Product Safety Recall

17036 Passenger Presence System

Reference Number: N162080281

Revision: 02

4885644

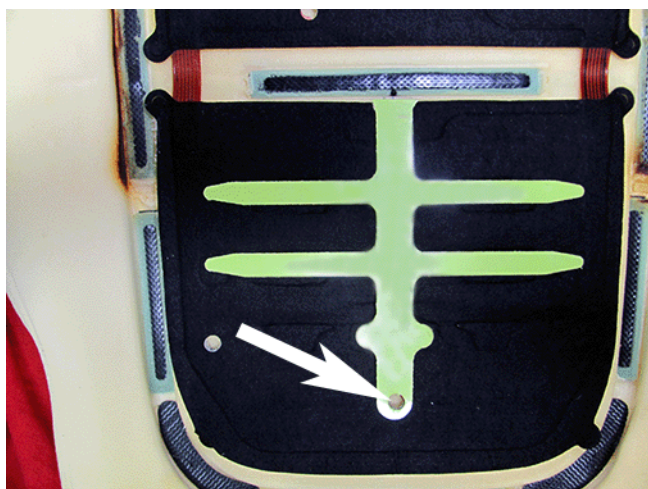
3. Using a ruler, locate the center of the seat pad in the area shown.
4. Mark the center with a permanent marker.

4885648

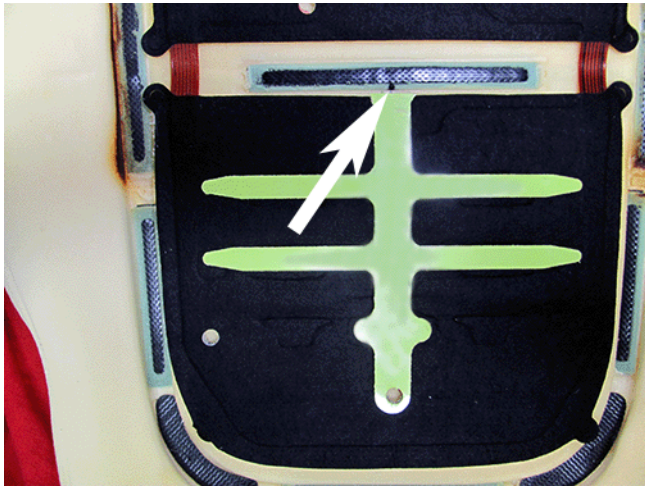
6. Center the hole in the reinforcement strip with the hole in the seat pad.
